In the Matter of)
Pa'ina Hawaii, LLC)
Materials License Application)
_____)

Docket No. 30-36974-ML
ASLBP No. 06-843-01-ML

INTERVENOR CONCERNED CITIZENS OF HONOLULU'S
AMENDED ENVIRONMENTAL CONTENTIONS #3 THROUGH #5

Tsunami Evacuation Maps from Ewa Beach to Airport, and from Airport to Waikiki (shaded areas indicate potential inundation zones that need to be evacuated horizontally or vertically in solid structures)

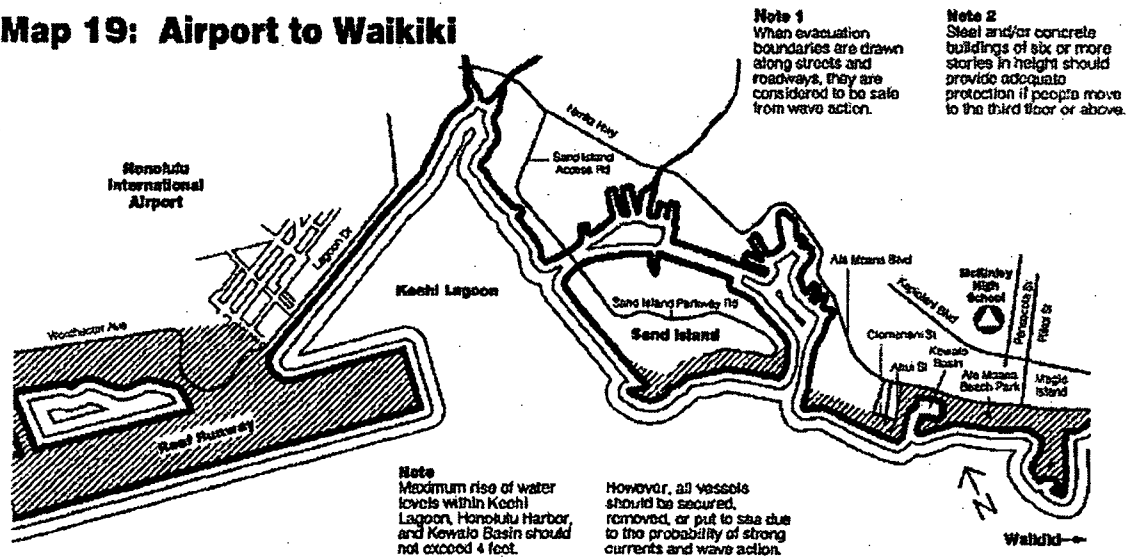
- Inaccurate statements that Honolulu International Airport is above the tsunami evacuation zone, when the State Civil Defense maps show the reef runway and various airport facilities are within the zone of potential tsunami inundation. Notably, the Draft Topical Report fails to recognize that the proposed irradiator site itself is in a tsunami evacuation zone.

Current evacuation maps are based on original maps prepared by the late Prof. Doak Cox and the present reviewer, which relied primarily on historical tsunami data using empirical methods, rather than numerical modeling (Cox & Pararas-Carayannis, 1967). This method tends to underestimate the potential impact of a tsunami, including inundation limits and runups. For example, unusual underwater or shoreline barriers such as reefs, roads, trees, buildings, and other features could focus the tsunami energy so strongly that runups and inundations could far exceed current estimates.

Figure 3. Airport Diagram Honolulu International Airport

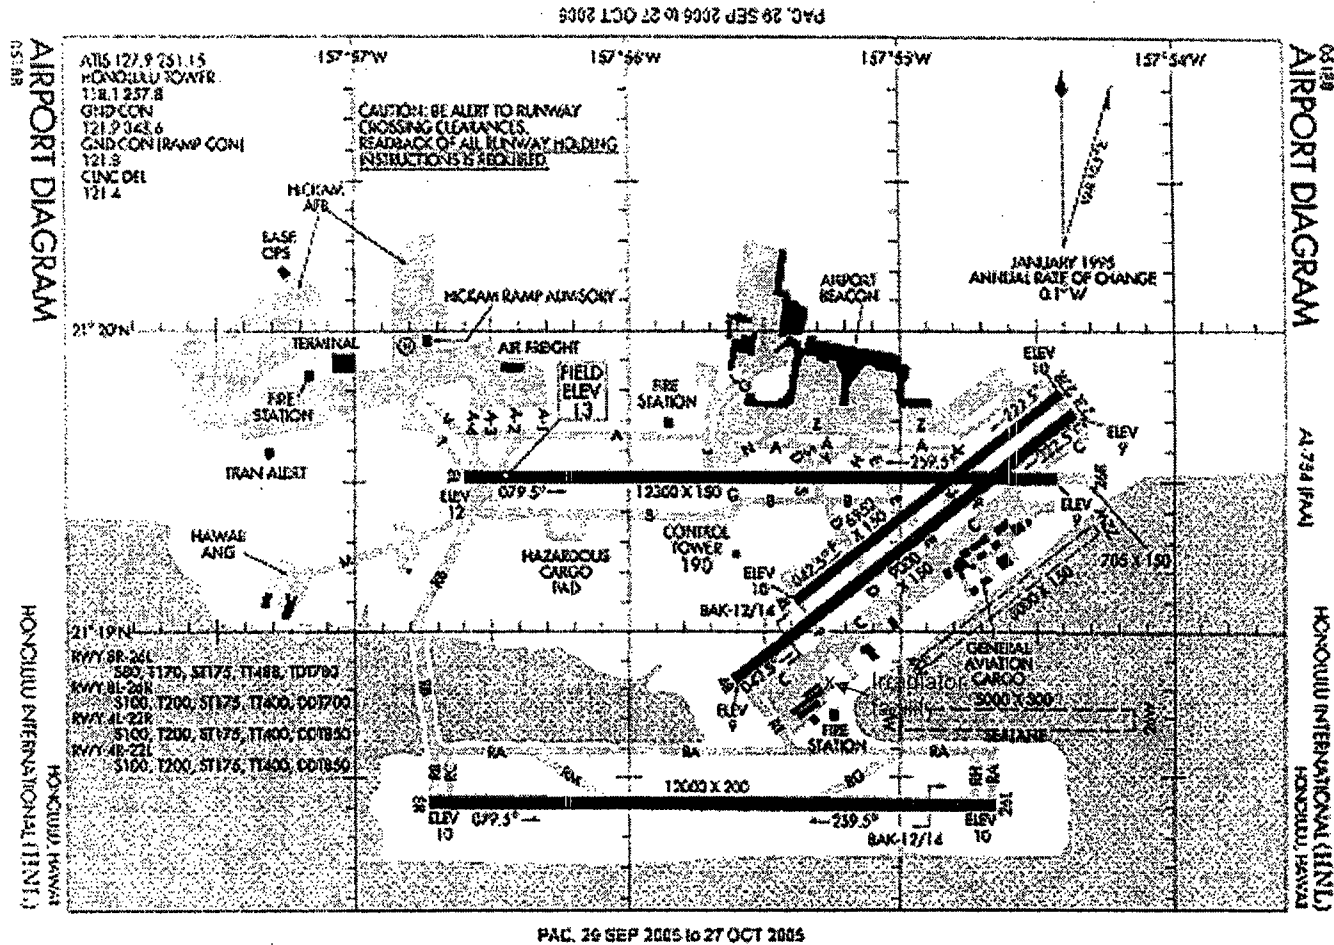
As seen in Fig. 3, the proposed facility is located extremely close to and lies between the runways (4R,22L) and (8R,26L), the reef runway. It is approximately $\frac{1}{4}$ mile from each runway and a little more than $\frac{1}{2}$ mile from the major runway (8L,26R). Table 7 lists the distances of the proposed facility from the center of each of the four runways. The conditional probability distributions are probability estimates in one square mile blocks. That is, given a crash, the conditional probabilities provide the probability that the crash takes place in an area of one square mile. As seen in Table 7, the centers of all runways are within one mile of the proposed facility.

Figure 5. Impact of B767 with steel structure at 100 mph.

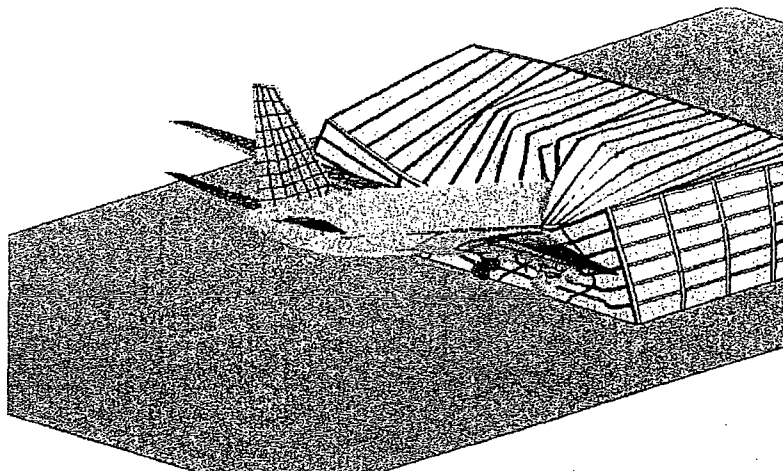
The aircraft was assumed to impact the structure head-on while traveling on the ground at a speed of 100 mph.² The “flight path” was assumed to be parallel to the ground and perpendicular to the rear façade of the structure. As depicted in Figure 5, the calculations indicated that the aircraft will crash through the columns and girders of the building. Impact of the structure at any angle would produce similar results.

Because the building was modeled with a toughness that could not be achieved in practice, this simulation results in acute bending of the columns and the girders, visible in Figure 5. Under actual conditions, many of the columns and girders would fracture or be torn off the connections. Debris and fuel would fill the structure, and the fuel would be expected to ignite explosively, causing a massive conflagration. The total damage within the structure would depend on the existing fire load, including the fuel load and the flammable materials within the building. However, the fire is likely to soften all metals, burn all non-metals, and deteriorate the concrete. This could result in a breach of both the source assemblies and the pool, allowing shielding water to escape. The Co-60 sources could also be exposed if extreme temperatures evaporate the pool water or if the force of the impact disperses the source. In addition, all personnel in the building would likely be killed or incapacitated in the event of a crash and conflagration, and Pa'ina Hawaii's proffered emergency procedures would be rendered useless, because no personnel would be there to implement them.
